ENVIRONMENTAL CONCERNS

The proposal does not meet the criteria set out in the Shoalhaven development control plan (2014), Chapter N19 Precinct 4.

Figure 2: proposed development demonstrating a series of horizontal and identical plates regarded as 'undesirable building form' in the design guide.

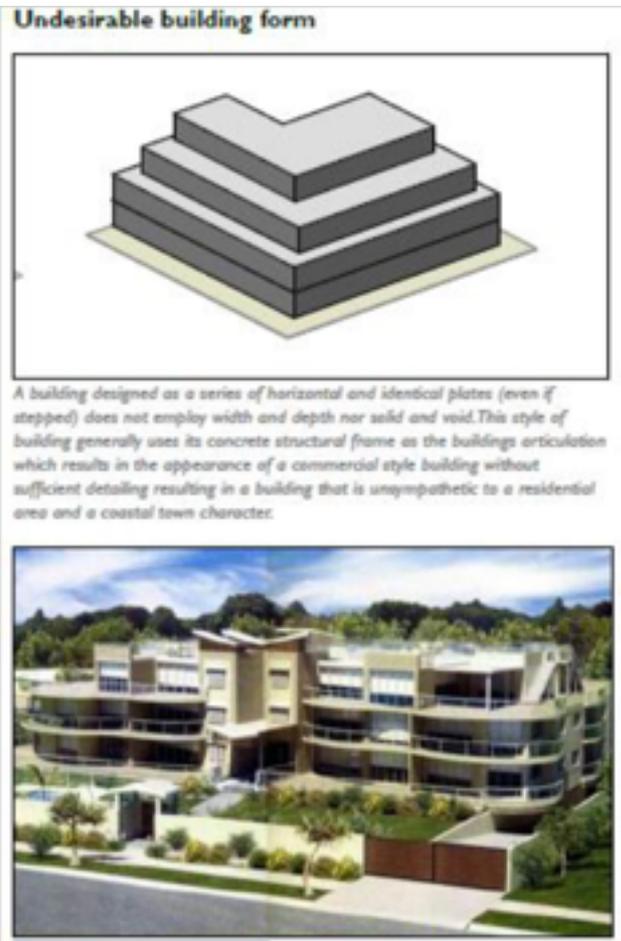
All the B4 precincts in Huskisson are to comply with the accompanying Design Guide. **The development does not avoid the ‘undesirable building form’ defined as a series of horizontal and identical plates (even if stepped).** See Figure 1 and 2

The Design Guide, page 1 specifically describes 'undesirable building form' as a series of horizontal and identical plates (even if stepped), unfortunately the proposed development is a series of horizontal and identical plates as mentioned previously.
